Re: 1011 Greacen Point Road - Appeal of Issuance of Building Permit

We are co-counsel with Marks DiPalermo Wilson, PLLC, to the owners (the "Owners") of 1011 Greacen Point Road (the "Subject Property") in connection with the above referenced matter. Per the schedule laid out at your meeting on September 3, 2025, we write in response to the Appellants' submissions dated December 16, 2024, July 3, 2025, and September 25, 2025. As set forth in detail below, portions of the Appeal should be dismissed on procedural grounds and, in any event, the entire Appeal should be denied on its merits.

The Appellants submitted a letter from Tectonic Engineering Consultants, P.C., dated July 22, 2025 (the "Tectonic Letter"). The Tectonic Letter, among other things, calls into question the designation of the lower level as a "Cellar" and how the building height was calculated. Below is a detailed response to those portions of the Tectonic Letter with Tectonic's comments followed by our response and supporting diagrams. In addition, submitted herewith are the current Average Grade Calculation plan dated July 31, 2025 (attached as **Exhibit 2**), and architectural plans showing the elevations of the

Figure 1.

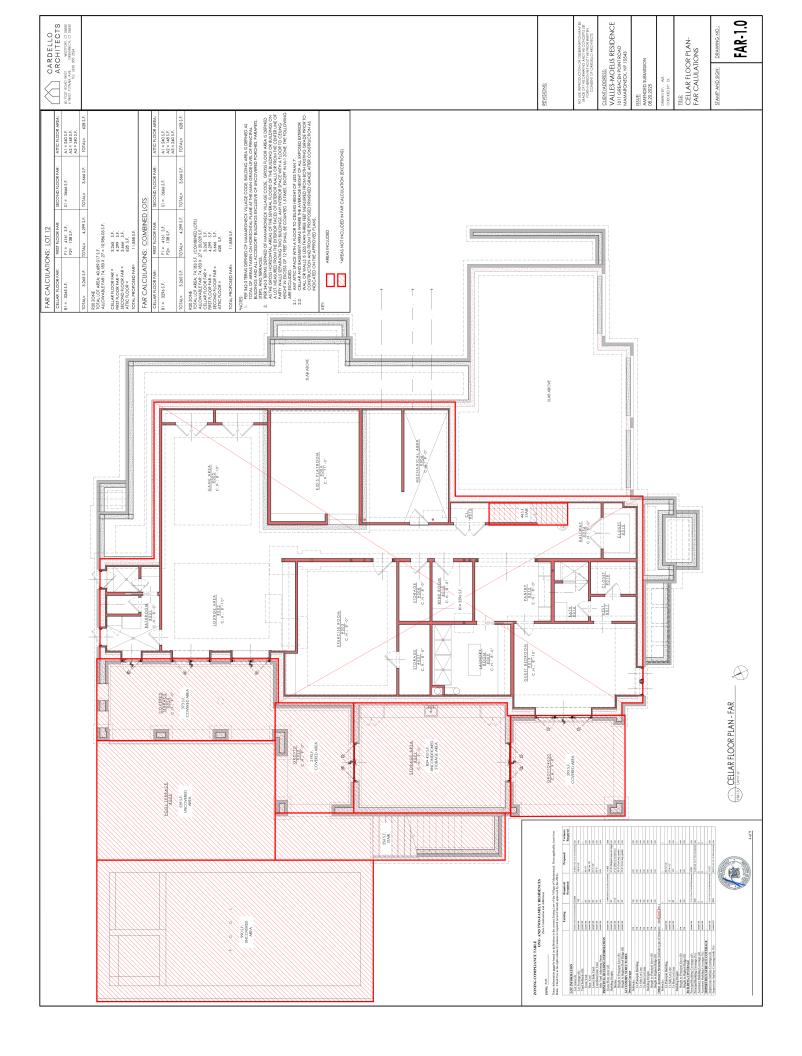
2. A review of the Architectural Plans shows the finished floor elevation of the initial floor to be at elevation 15.00 and the finished ceiling at elevation 23.67 and 23.00, depending on the room. Those rooms with a finished ceiling elevation of 23.67 have 50% of their 8'-8" height (4'-4") at elevation 19.33 (15.00+4.33), which is higher than the average finished

grade of 19.13. Those with a finished ceiling of 23.00 have 50% of their 8'-0" height (4'-0") at elevation 19.00, which is lower than the average finished grade.

Response: Ceiling height in the cellar varies. Approximately 72% of the cellar has an 8'-0" finished ceiling height, with all perimeter wall areas at 8'-0" (see Figure 1 below). All areas in red have a ceiling height of 8'-8". The game room has a ceiling height of 11'-0". All other areas have a ceiling height of 8'-0". Using the correct average finished grade of 19.37' and applying the definition of CELLAR (more than half of its height below the average established curb level or finished grade), the entirety of the level's average height is below grade (see Figure 2 below). Furthermore, the few interior areas with 8'-8" ceilings are non-perimeter spaces (see Figure 1) and represent less than 20% of the total ceiling area and still have a greater height that is below the average proposed finished grade plane, see (Figure 4) below.

Figure 2.

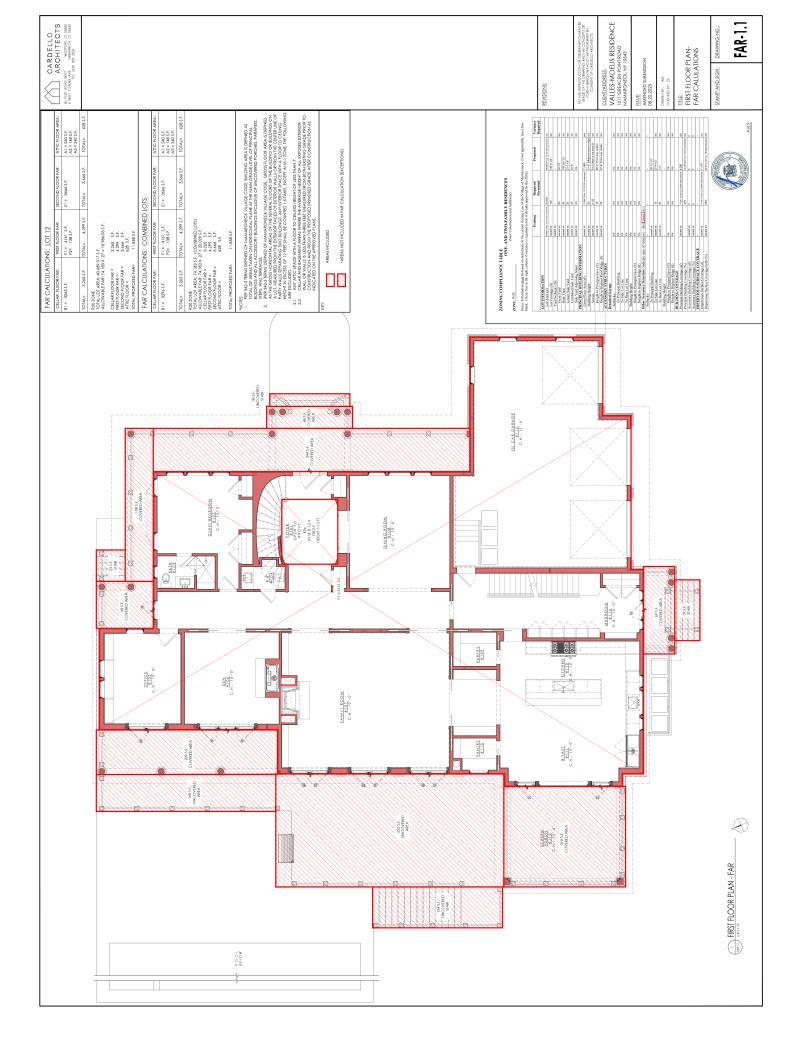
4. Since the rooms with a finished ceiling height of 8'-8", have more than half their height above the average finished grade, by definition they would be designated as Basement and not Cellar, and as such would constitute an additional story for the structure. Plans need to be revised to ensure that all rooms on the cellar floor meet the criteria for a cellar, otherwise the proposed building will have 3.5 stories and exceed the 2.5 story maximum provided in the code.

Response: Per the Zoning Code, classification is determined by whether more than half of the height, measured from floor to ceiling, is below the "average established curb level or finished grade of the ground adjoining the building". The entirety of this level is more than

half below the calculated average finished grade of 19.37'. Areas that are 8'-0" are compliant, with more than half of their height below the proposed average finished grade (see Figure 2 above). Areas that are 8'-8" in ceiling height are also compliant, with more than half the height below the proposed average finished grade, (see figure 4 below). The area that is 11'-0" is compliant, with more than half the height being below the proposed average finished grade plane (see Figure 3 above). Accordingly, the lower level is properly classified as a cellar under the Zoning Code and does not count as a story.

Figure 3.

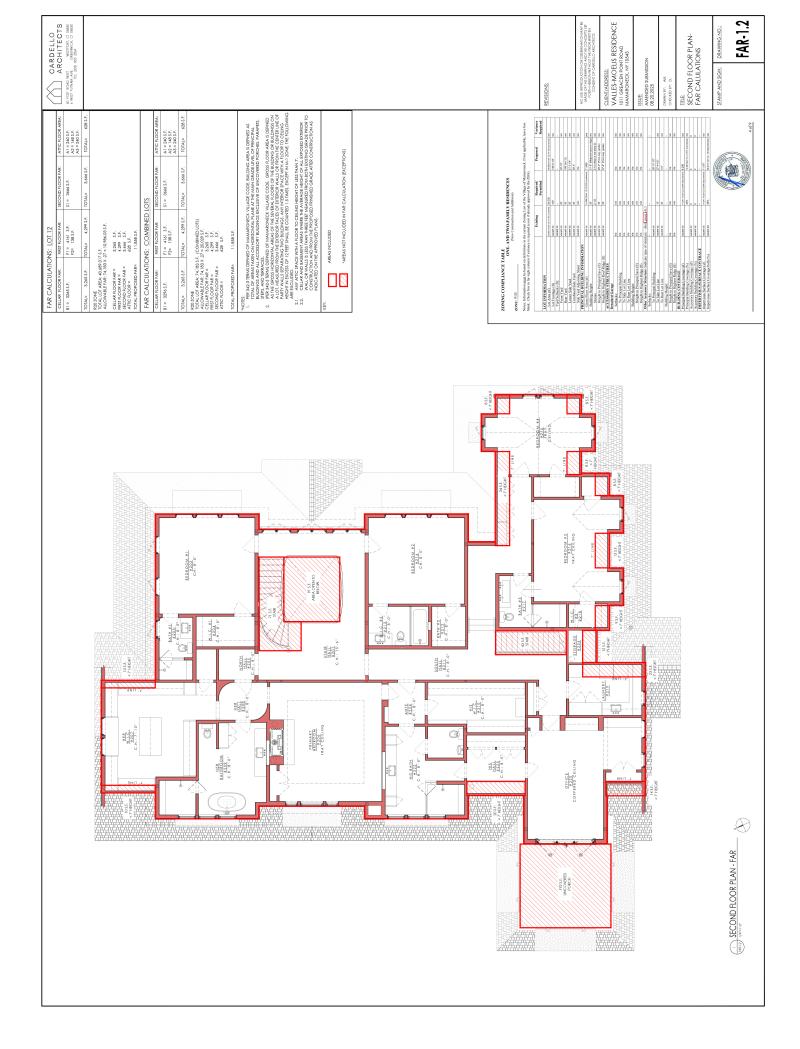
3. It should be noted that the Game Area room depicted on sheet A-3.2 appears to have a ceiling height of 11'-0" instead of the 8'-8" noted on the sheet.

**Response:** The game room does have a ceiling height of 11'-0"; however, the slab in the game room is dropped to elevation 12.667' to create an 11'-0" finished ceiling. This design places an even greater portion of this room's wall height below the average finished grade plane (see Figure 3 below).

# AVERAGE GRADE PLANE PLAN

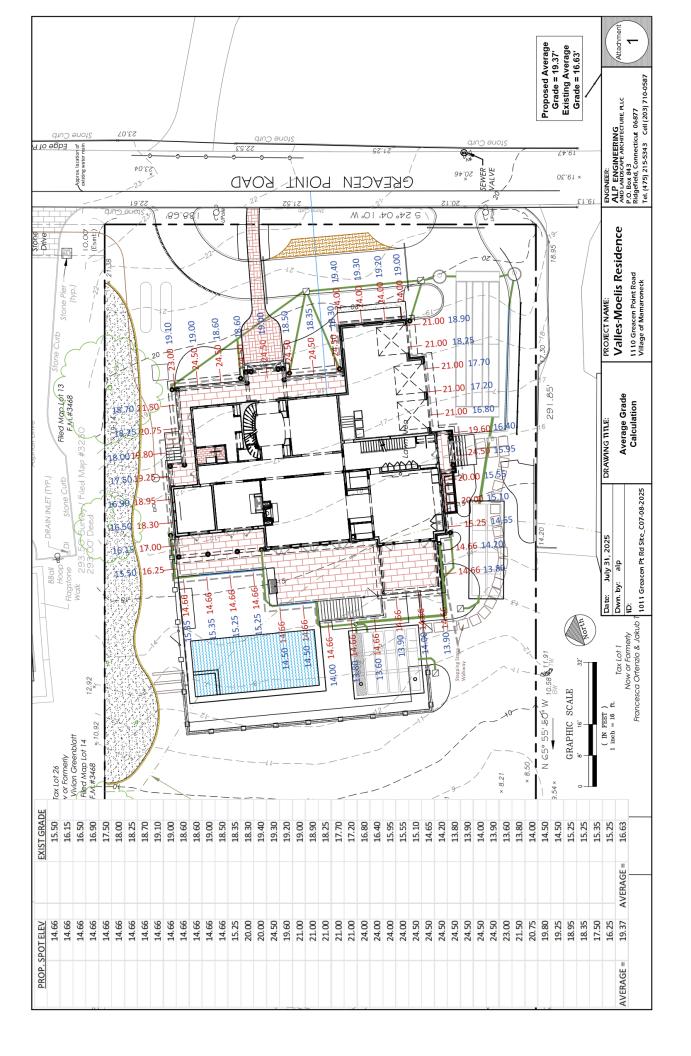
1. The Attachment 1 "Average Grade Calculation" prepared by ALP Engineering (01/21/2025) indicates a calculated average finished grade of 19.37'. However, upon inspection of the data presented in the exhibit, four of the finished grade data points do not match the revised grading plan or the definition of finished grade. Recalculating the average finished grade using the finished grades from the revised grading plan provides a new average finished grade elevation of 19.13, which is to be used in process of ascertaining the designation of the initial floor as basement or cellar.

Response: The average finished grade has been calculated in direct accordance with the Village's definition of GRADE, FINISHED: "At any point along the wall of a building, the elevation of the completed surfaces of lawns, walks and roads adjoining the wall at that point."

All points used in the calculation are located along the building perimeter and represent completed surface elevations of lawns, walks, or roads that adjoin the building wall. The Zoning Code does not prohibit the adjustment of grading along the perimeter of the building. The methodology is consistent with common engineering practice and prior Village applications. The resulting calculation of 19.37' is based on the full perimeter and therefore reflects the correct "average finished grade" per the definition in the Zoning Code.

# ARCHITECTURAL ELEVATIONS

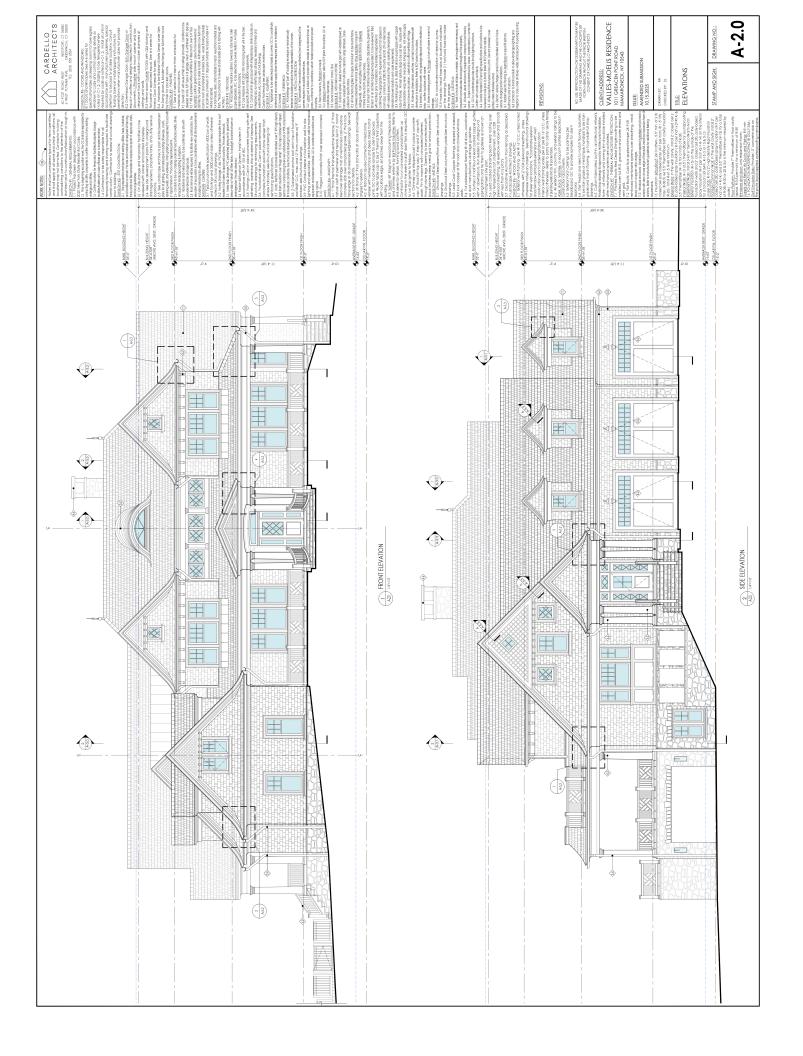
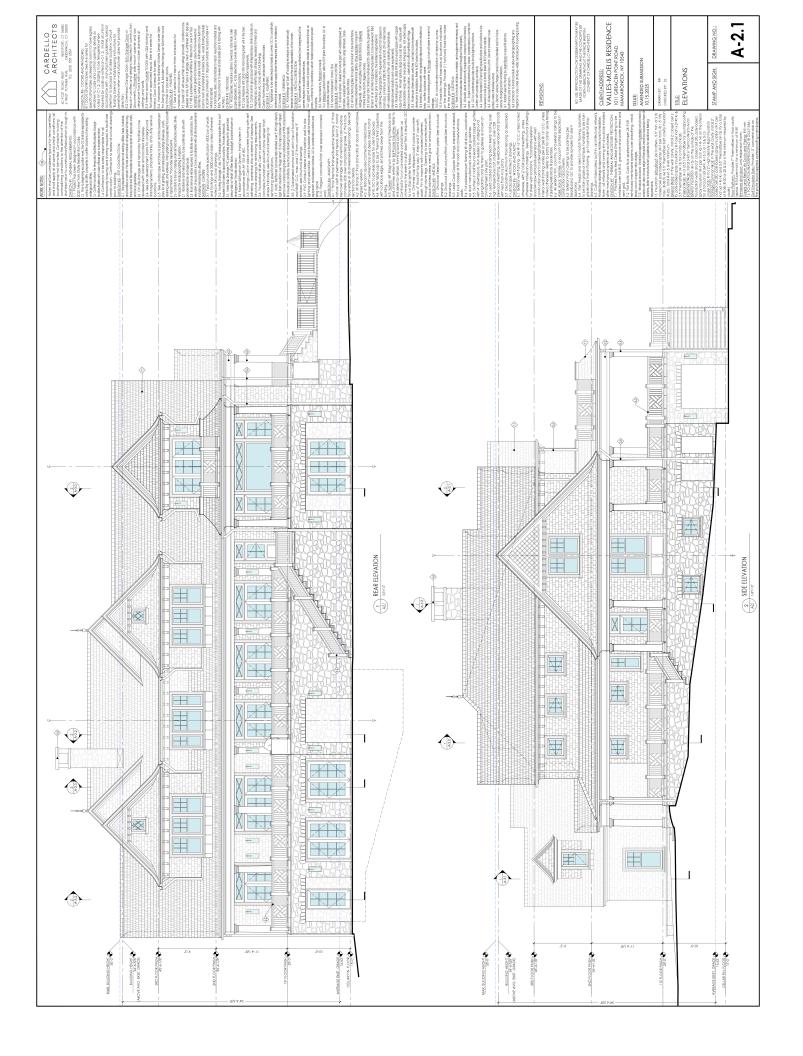
1. In order to establish the building height elevation, the average existing grade adjacent to the exterior building walls had to be determined, as did the vertical distance between the roof peak and highest eaves. Neither the architectural nor engineering plans indicate the average existing grade adjacent to the exterior building walls. In review, the existing grade taken at the same locations as the finished grade elevations depicted in the Attachment 1 "Average Grade Calculation" were tabulated and an average existing grade of 16.493 was calculated. The architectural plans do not provide the elevation or height of the highest eaves or roof peak, and as such this distance was scaled from the Rear Elevation on sheet A-2.1 and found to be 8'-6".

The building height dimensions up to the 3rd floor add up to 30.51 ft. The scaled height from the 3rd floor to the roof peak was found to be 11.33 ft, giving an overall vertical distance to the roof peak of 41.84 ft. Subtracting out 1/2 of the distance between the roof peak and the highest eave of 4.25 ft (8.5/2), provides the vertical distance of 37.59 ft, above the cellar floor which is at elevation 15.00. This in turn means the maximum building height is at elevation 52.59 (37.59 + 15.00). Since the average existing grade is at elevation 16.49, then the maximum building height is actually 36.10 ft (52.59 - 16.49), which is 1.1 ft in excess of the 35.0 ft height allowed in the code.

**Response:** As set forth above, in measuring building height for one- and two-family dwellings, the measurement is "the vertical distance to the highest level of the highest point of the roof if the roof is flat or mansard or to the mean level between the eaves and the highest point of the roof if the roof is of any other type, measured from the average level of the existing grade prior to construction adjacent to the exterior walls of the building."

The calculated average existing grade is 16.63'. The highest eave is at elevation 45.510' (45'-6-1/8") and the roof peak is at 56.843' (56'-10-1/8"). The midpoint between these two is 51.177' (51'-2-1/8"). The vertical distance from the average existing grade (16.63') to this midpoint is **34.552'** (34'-6-5/8"), which is within the 35'-0" maximum allowed.
